Ohio Department of Natural Resources
DNR-250014 Mary Jane Thurston State Park Tree House Cabins
1466 State Route 65, McClure OH 43534, Wood County

ADDENDUM 06

Date of Addendum: 1/23/2026

1 CABIN B - FLOOR PLAN
1/2" = 1'-0"

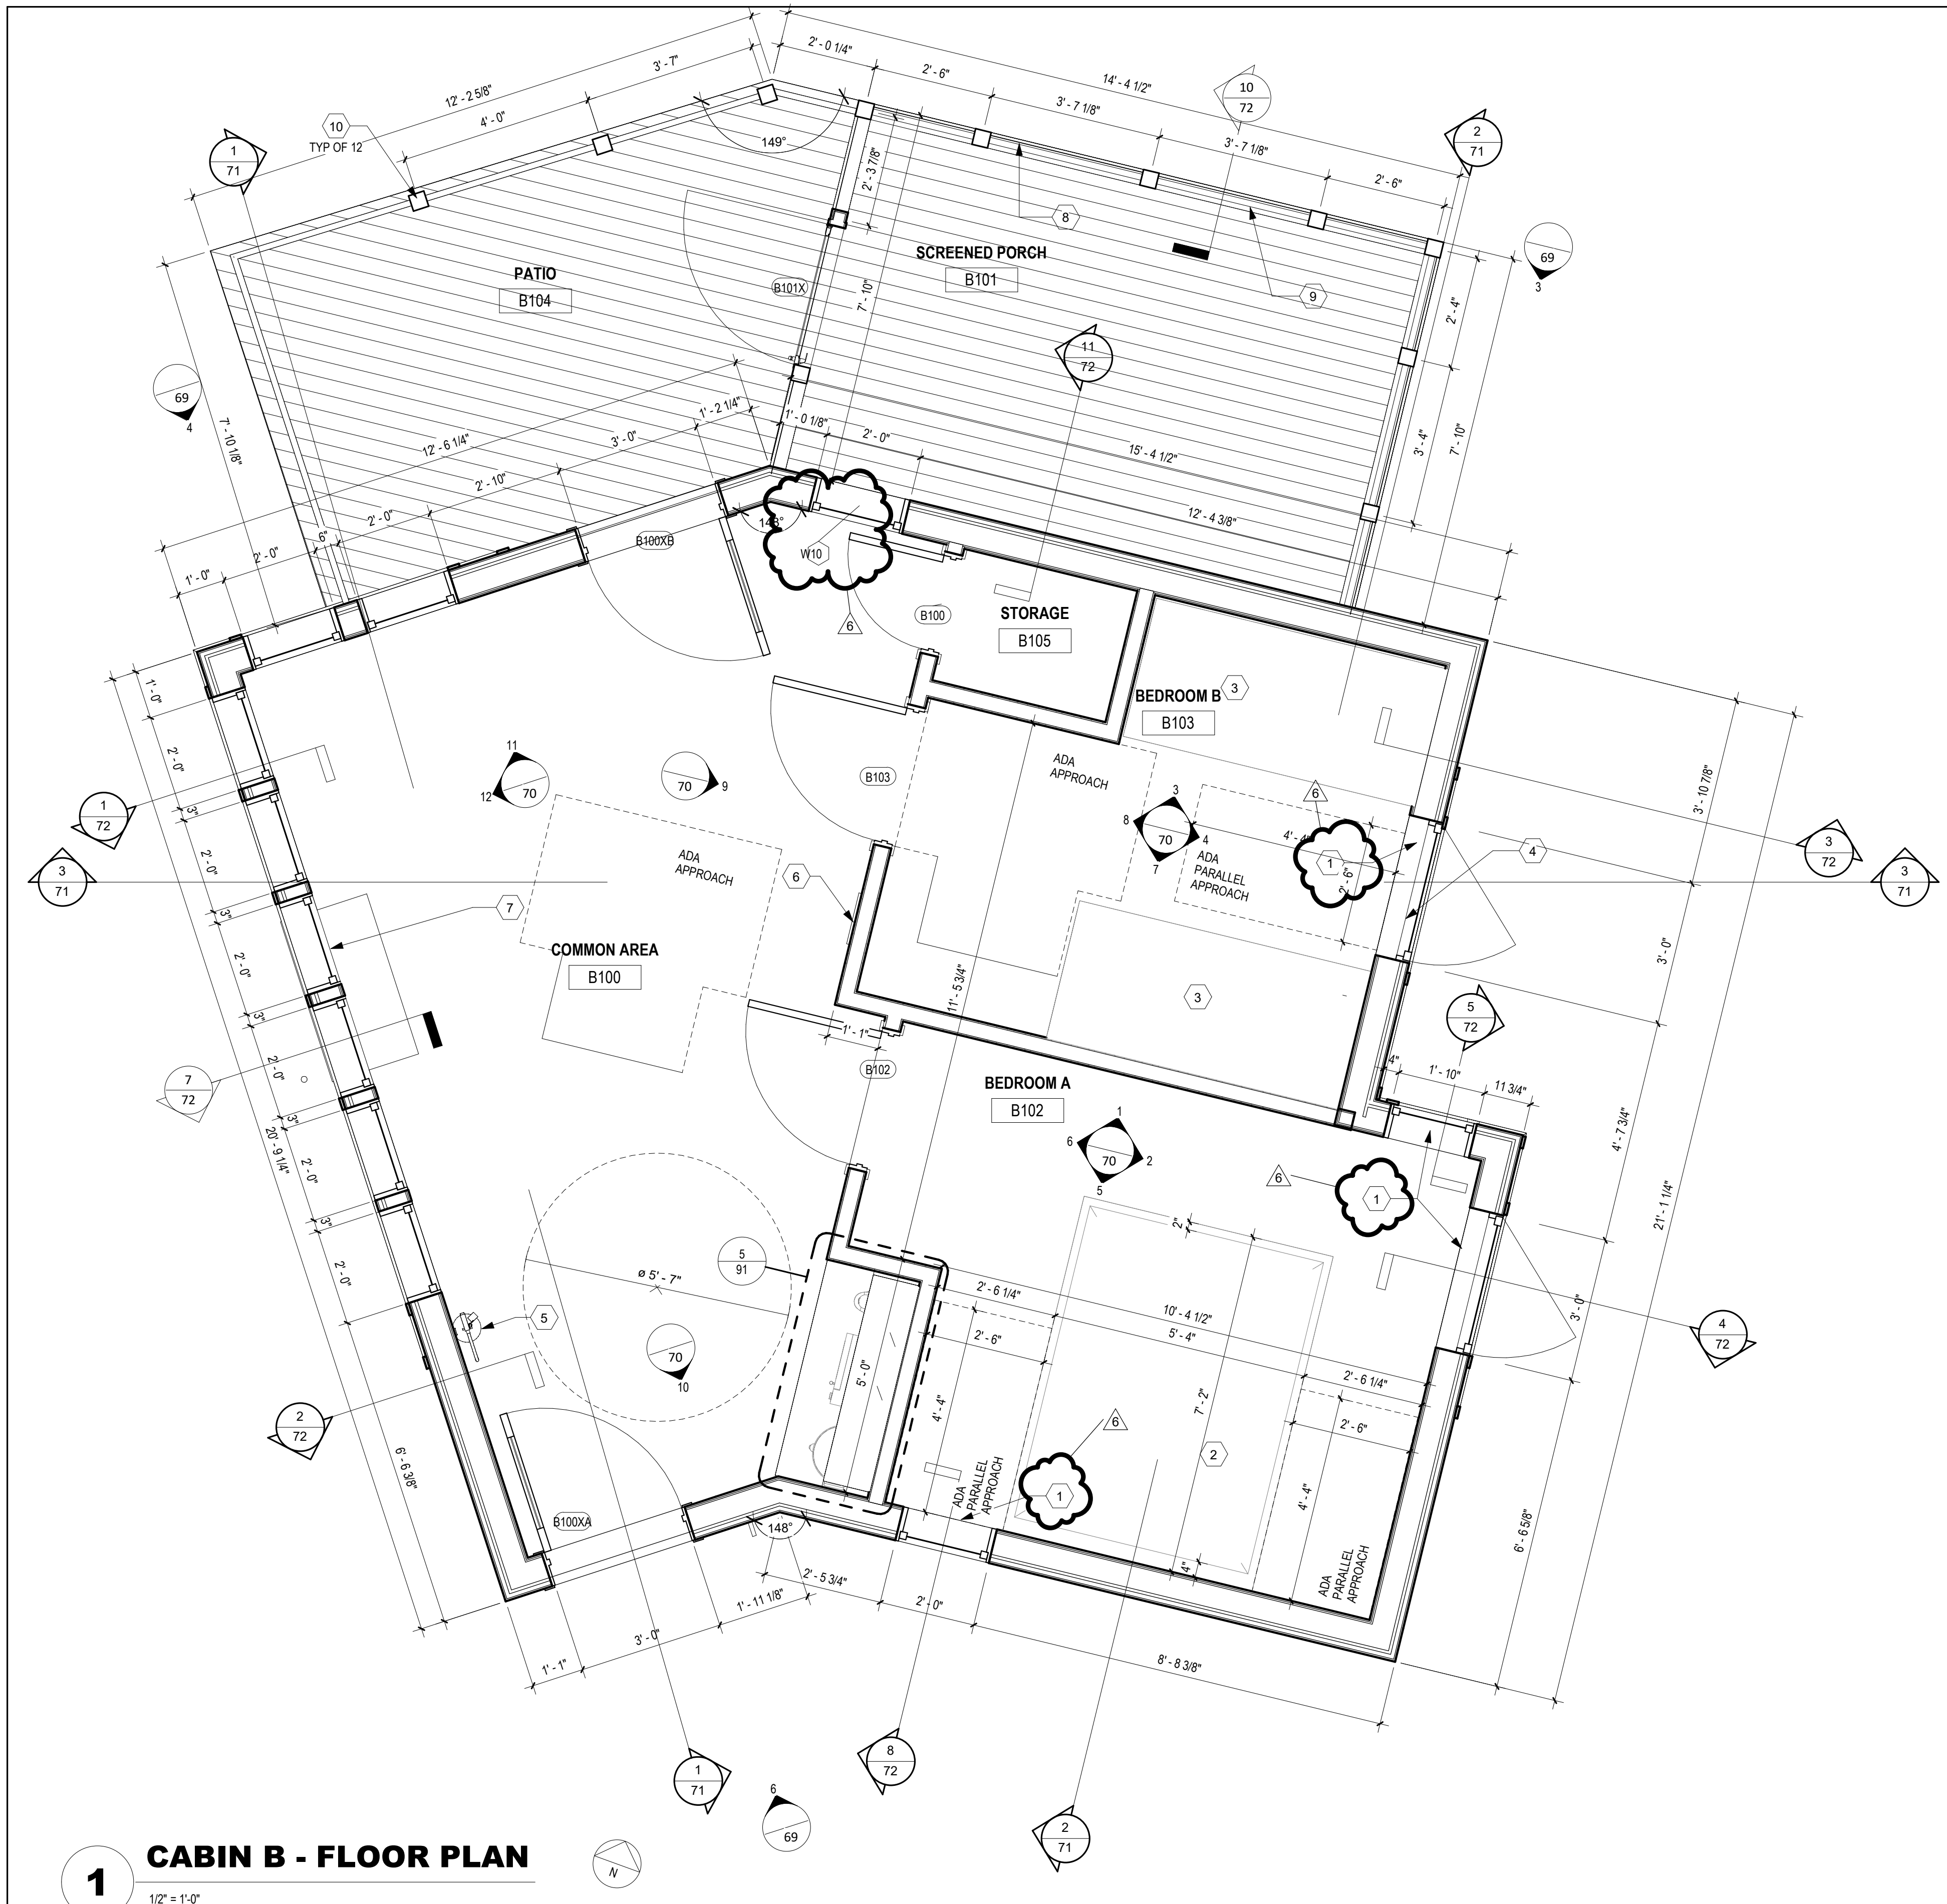
18. Sheet 62 – CABIN A - INTERIOR ELEVATIONS: Replace sheet in its entirety with attached.
19. Sheet 66 – CABIN B – FLOOR PLAN: Replace sheet in its entirety with attached.

CABIN B FLOOR AND ROOF FRAMING PLANS

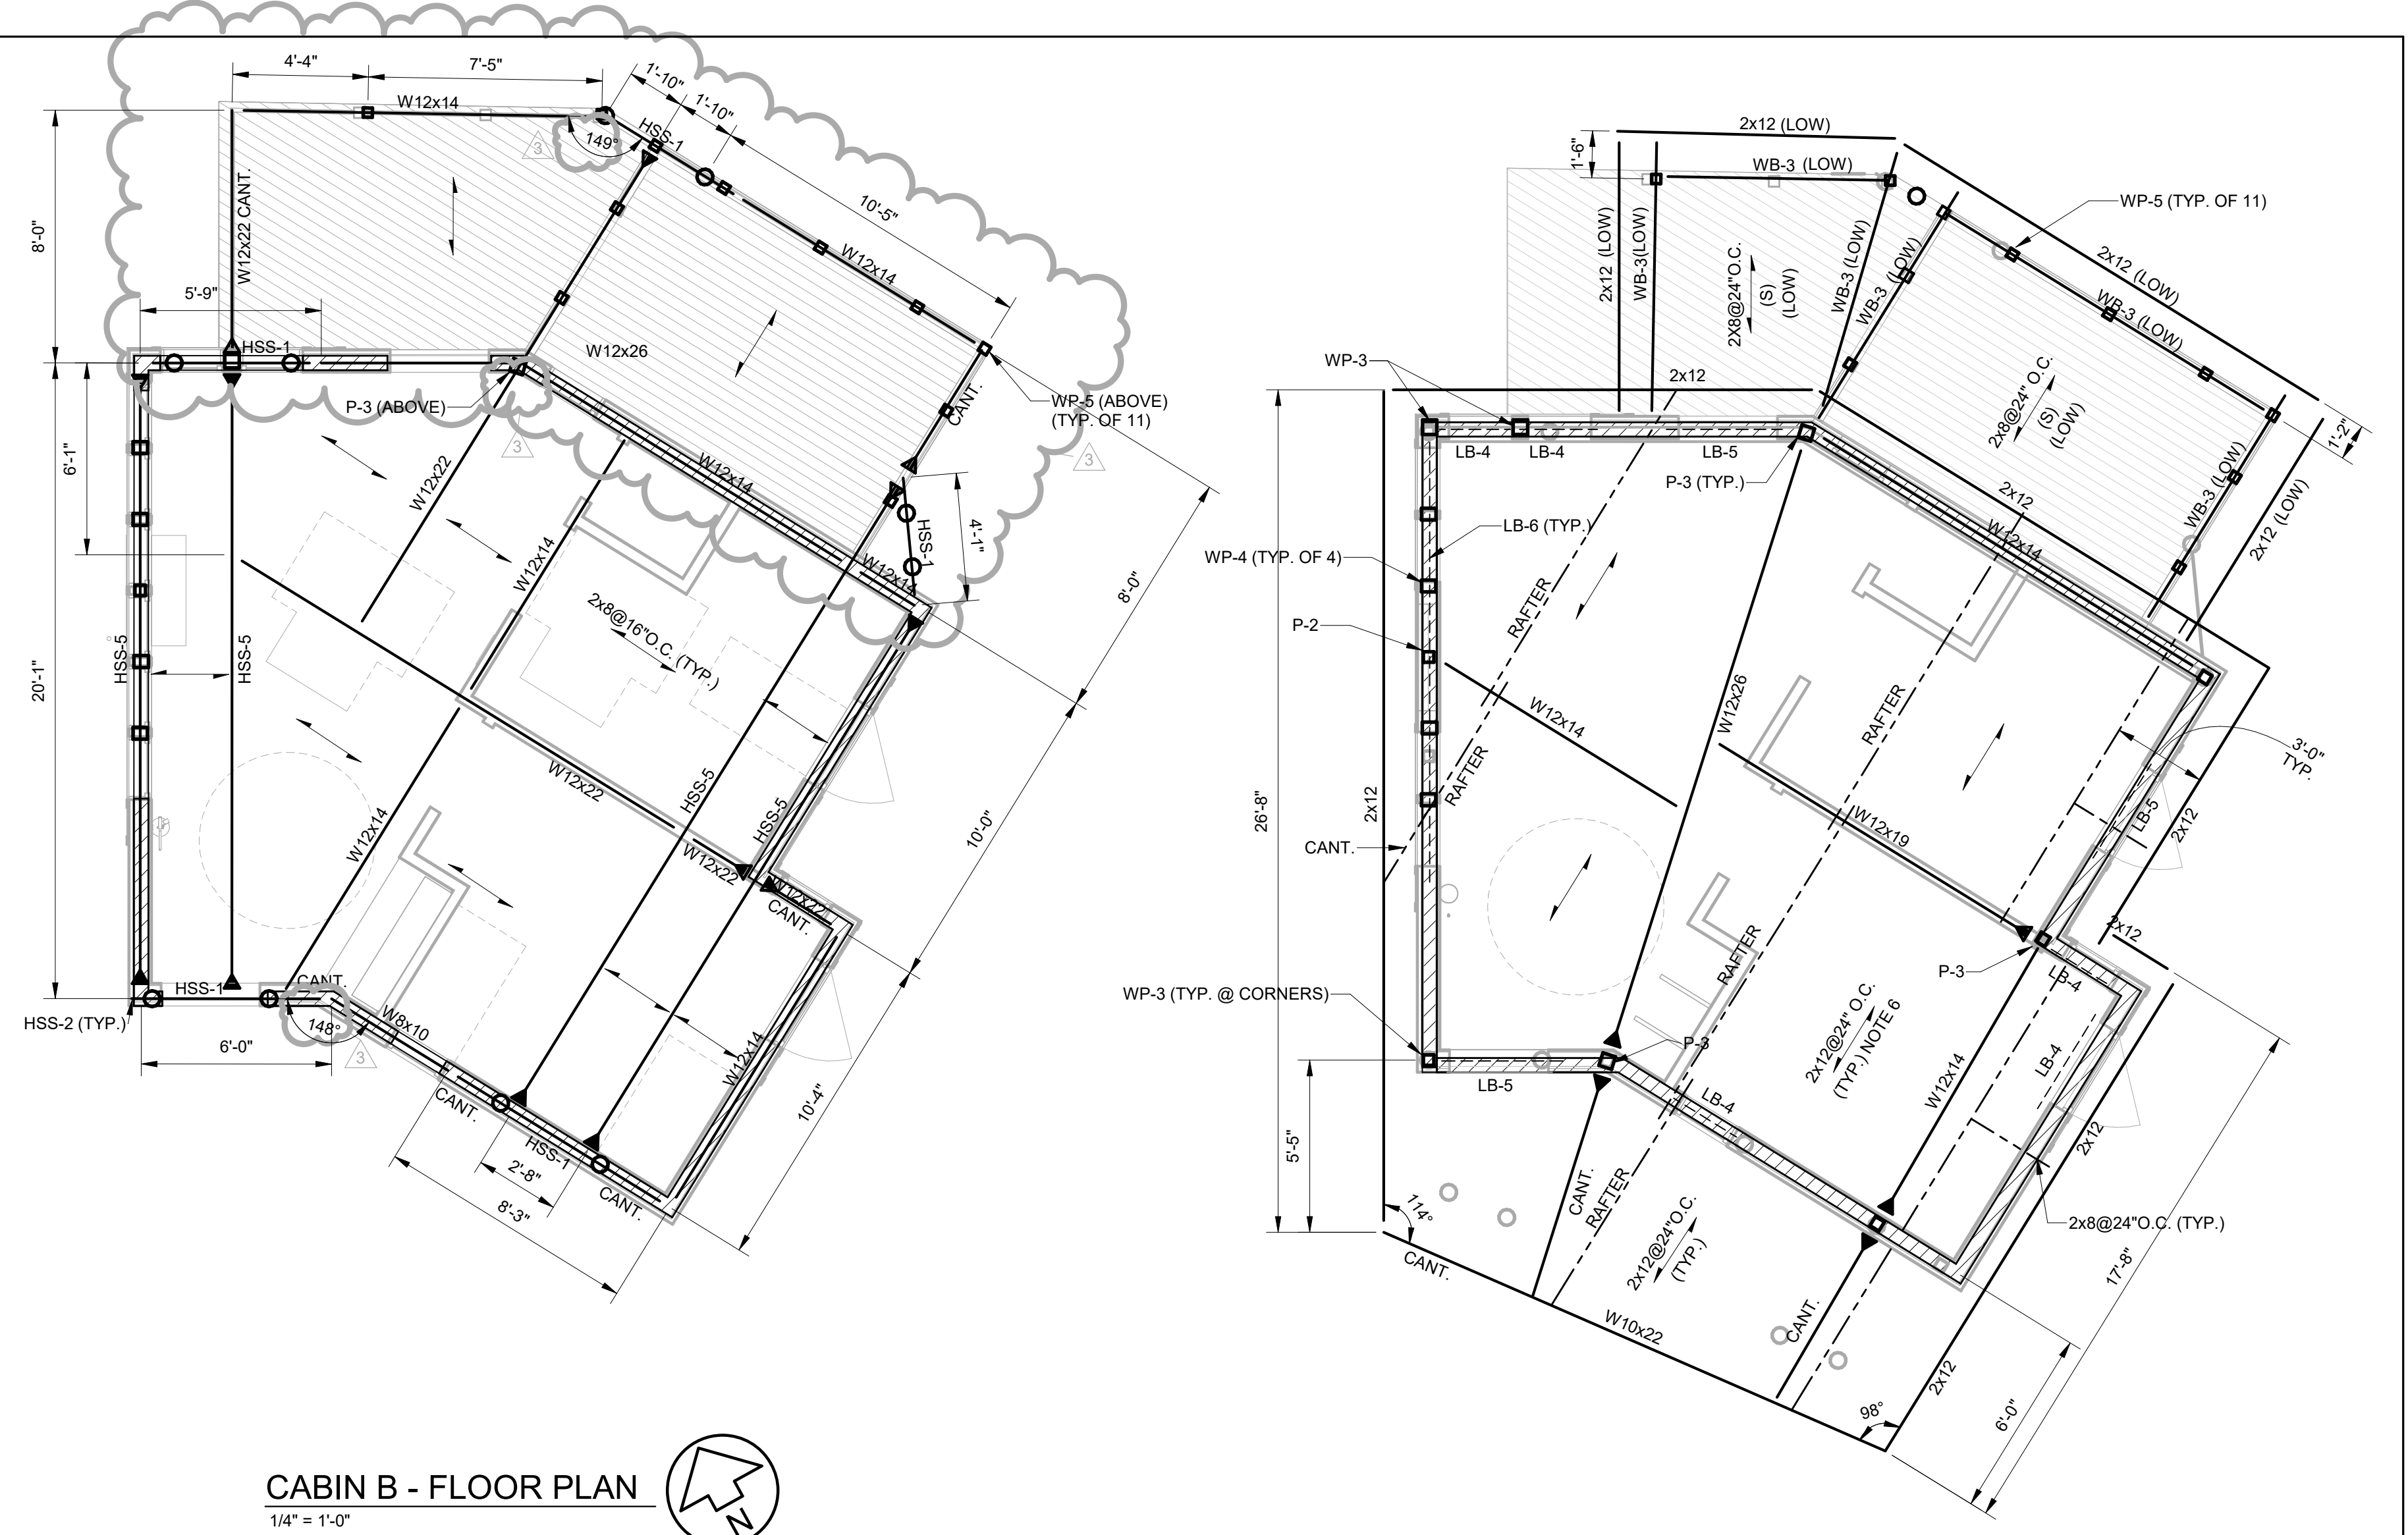
38. Sheet 112 NORTH AND SOUTH CABIN CLUSTER FLOOR FRAMING PLANS:
 - a. NOTES: Revise note 3 to read “All exposed steel to be hot dip galvanized.”
 - b. Legend: Revise WJ-1 to read “Denotes 2x8 floor joists @ 16” o.c. installed on top of steel framing provide H3 ties by Simpson – 2 per joist.”

41. Sheet 116 CABIN B FLOOR AND ROOF FRAMING PLANS: Replace sheet in its entirety with attached.
42. Sheet 117 CAMPING PLATFORM FRAMING PLANS: Replace sheet in its entirety with attached.
